**ADDENDUM NO. 4**

**11-2-2016**

**PROJECT:        WALTHAM POLICE STATION RENOVATION**

**CHANGES, CORRECTIONS AND CLARIFICATIONS**

**ITEM NO. 2 – REVISION TO DRAWING A112**

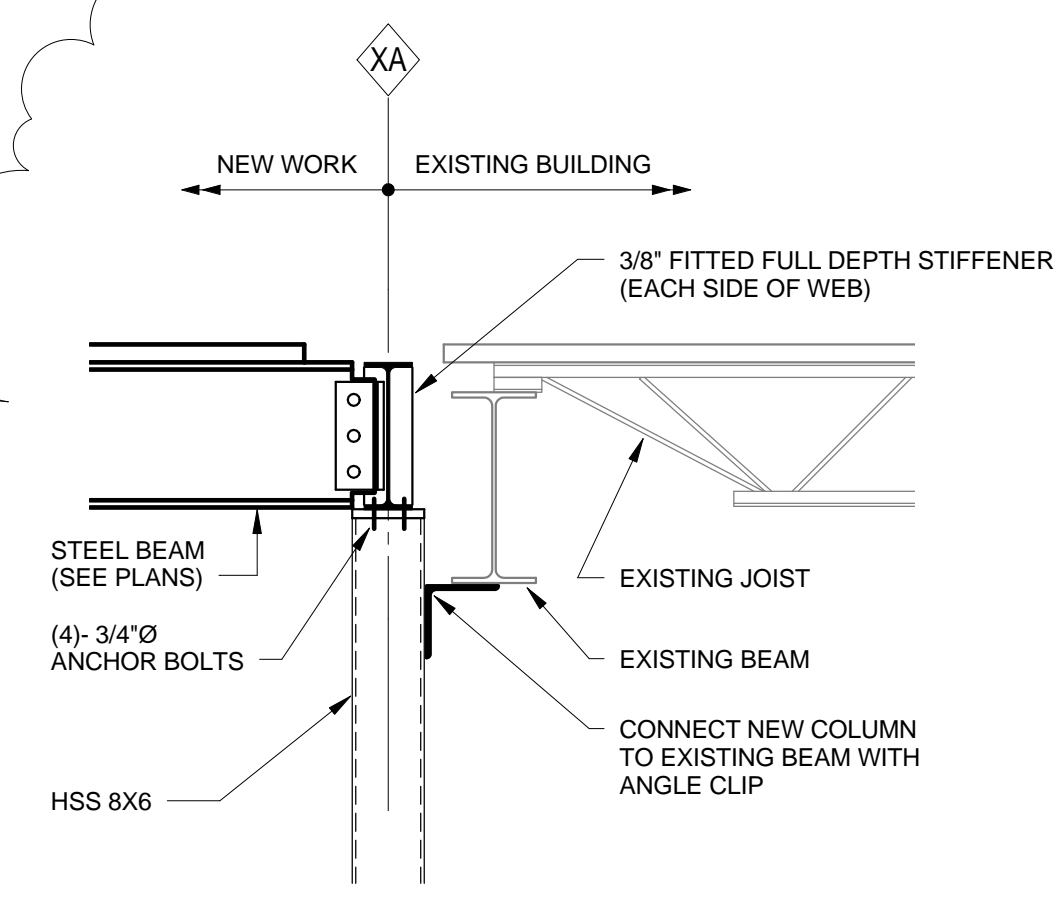
- A. The interior elevation key within LOBBY 115 shown in the enlarged plan #2 titled ENLARGED LOBBY/RECEPTION AREA was mislabeled as 15/A704. It should read 19/A704.
